Informal document Amending ‘Proposal for Amendments to the 03 series of Amendments to UN Regulation No. 79 (Steering equipment)’

Submitted by the expert from the European Association for Electromobility

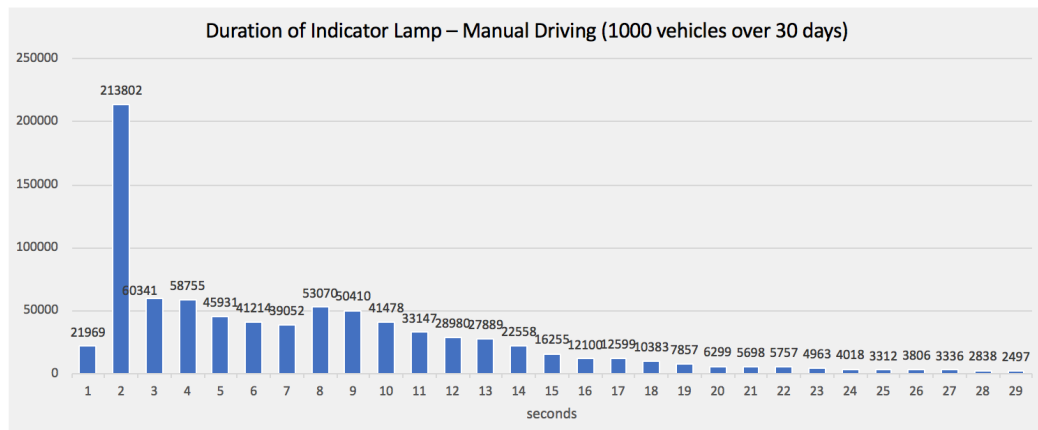
1. We suggest changing the maximum time for starting the lane change maneuver to 15 seconds based on accumulated data from real world driving that shows the following distribution of turn indicator times across 1000 vehicles in a one-month window. The 15 second value, corresponds to the majority of use cases and is in line with natural driving behavior.

The lane change manoeuvre shall not be initiated before a period of 3.0 seconds and not later than **15.0** ~~5.0~~ seconds after the deliberate action of the driver described in paragraph 5.6.4.6.2. above.
